## Modifications Notices

No. FE2-Z-2108008

**Modification Notice for UL certified rating and rating marking change due to transition of applicable UL standards , and change of safety standard mark due to transition of CSA standard certification for Miniature Basic Switch V thermosetting case, horizontal terminal series.**

[ Example of product marking ]

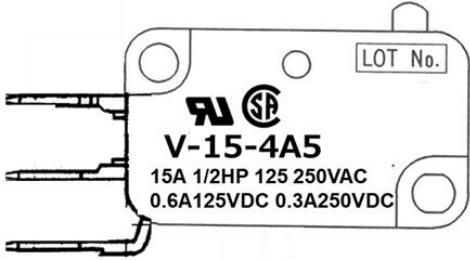
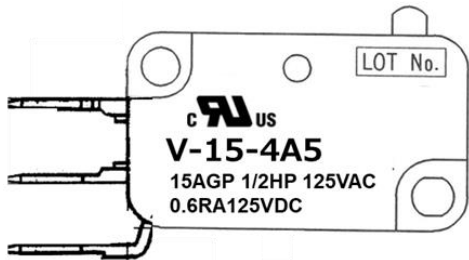
- (2) Change the UL mark and delate CSA mark on the product.

Before the change	After the change
<p><b>In case of V-15-4A5</b>                      (1) UL rating 15A 1/2HP 125 250VAC                      0.6A 125VDC 0.3A 250VDC                      (2) UL, CSA marking</p>  <p>The diagram shows the marking on the device before the change. It includes the UL and CSA logos, the model number V-15-4A5, and the ratings: 15A 1/2HP 125 250VAC and 0.6A 125VDC 0.3A 250VDC. A 'LOT No.' label is also present.</p>	<p><b>In case of V-15-4A5</b>                      (1) UL rating 15AGP 1/2HP 125VAC                      0.6RA 125VDC                      (2) cULus marking</p>  <p>The diagram shows the marking on the device after the change. It includes the cULus logo, the model number V-15-4A5, and the updated ratings: 15AGP 1/2HP 125VAC and 0.6RA 125VDC. A 'LOT No.' label is also present.</p>
